Access Compliance Report

Public Rights-of-Way

Intersection ID: 27760	Main Street: BALLANTYNE_COUNTRY_CLUB_DR	Cross Street: BALLANTYNE_CROSSING_AV	Location: SW
ADA ID: D40FC488685C	Ramp Type: Perp	Initial Pass/Fail: Fail	Overall Compliance: No
Severity Score: 12.5			
Codes/Mitigation Info/Possible Solution		Field Measurements/Component Compliance

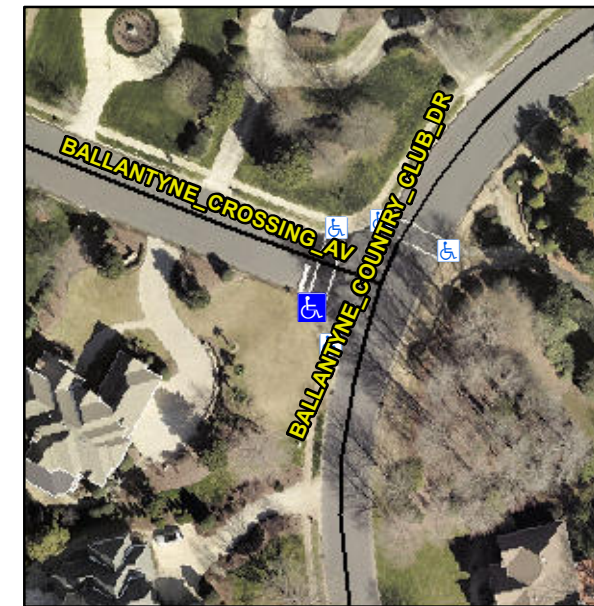
Not Found, R304.2.2

Compliance	Description	Data	Compliance	Description	Data
N/A	Ramp Length (in)	40.0	No	Ramp Slope (%)	11.7
Yes	Ramp Width (in)	48.0	Yes	Ramp XSlope (%)	1.3
N/A	Flare Type LT	N/A	N/A	Flare Type RT	N/A
N/A	Flare Slope LT (%)	N/A	N/A	Flare Slope RT (%)	N/A
N/A	Flare Traversable LT?	N/A	N/A	Flare Traversable RT?	N/A
N/A	Landing Length (in)	N/A	N/A	DWS Provided?	N/A
N/A	Landing Width (in)	N/A	N/A	DWS Contrast?	N/A
N/A	Landing Slope (%)	N/A	N/A	DWS Length (in)	N/A
N/A	Landing X Slope (%)	N/A	N/A	DWS Full Width?	N/A
N/A	Landing Curb? (Y/N)	N/A	N/A	DWS Offset (in)	N/A
N/A	Shared Landing?	N/A			
N/A	Gutter Ponding?	N/A	N/A	Gutter Slope (%)	N/A
N/A	Gutter Lip Ht (in)	N/A	N/A	Gutter X Slope (%)	N/A
N/A	Painted X Walk1?	Yes	N/A	Painted X Walk2?	N/A
	X Walk 1 Direction	To NE		X Walk 2 Direction	N/A
N/A	X Walk 1 Width (in)	102.0	N/A	X Walk 2 Width (in)	N/A
	X Walk 1 Slope (%)	4.7		X Walk 2 Slope (%)	N/A
	X Walk 1 X Slope (%)	0.9		X Walk 2 X Slope (%)	N/A

Remove & Replace Entire Ramp.
